**CORRIGENDUM-III**

**RFP ENQ. No.- OCAC-NEGP-INFRA-0007-2021-22061 Dated 23.08.2022, for Selection of Agency for Implementation, Operations and Maintenance of OSWAN NOC**

### **6.3. OSWAN-NOC Layout:**

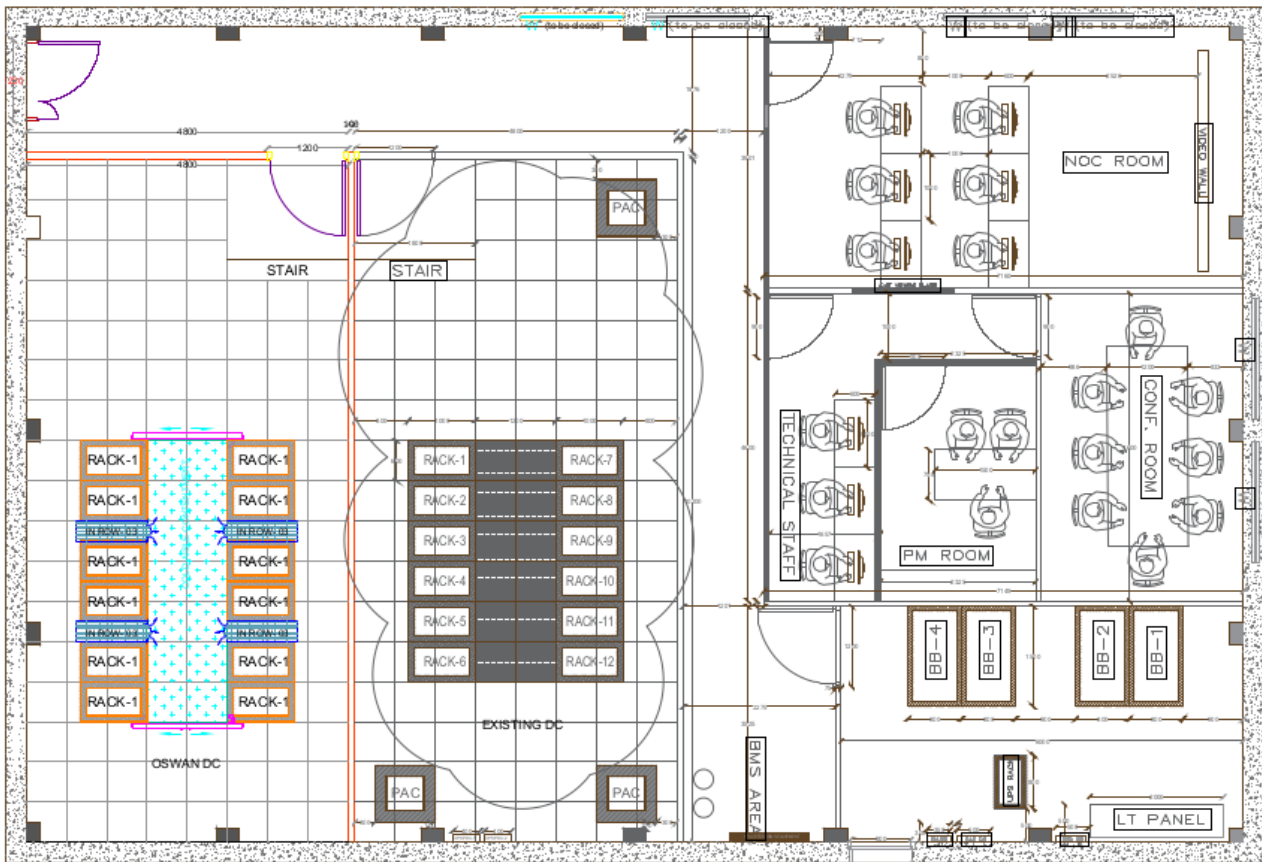
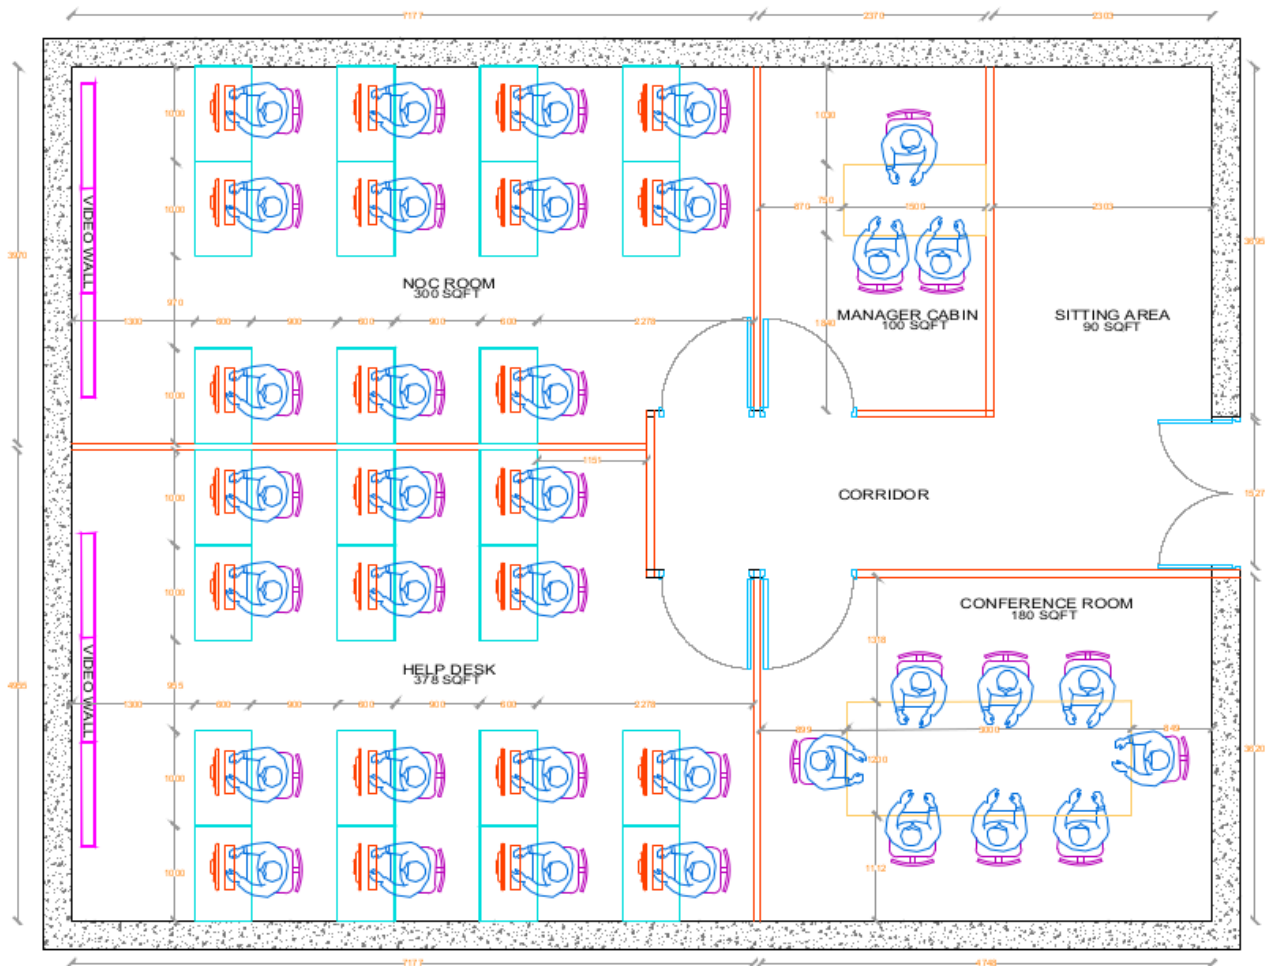
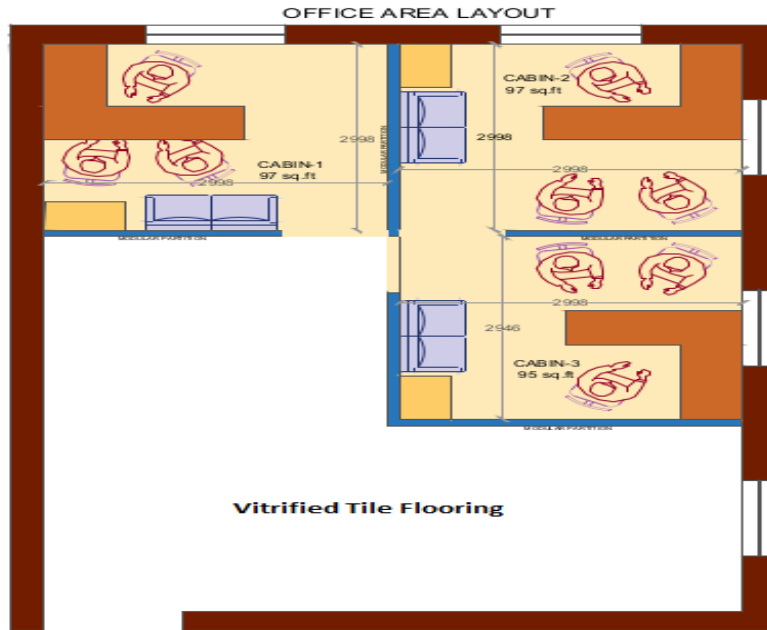
Sr. No.	Page No	Clause No	RFP Clause	Query /Clarification/ Suggestion if any asked		Modification/ Addendum/ Deletion/ Clarification
107.	36,37		The diagrams and layout are on the page 36 and 37	Is OSWAN NOC Room, Office Area Layout and OSWAN Helpdesk Room is final as per the OSWAN RFP doc ?		<b>Clarification:</b> It may change as per the space availability and as best practice of bidder solution.
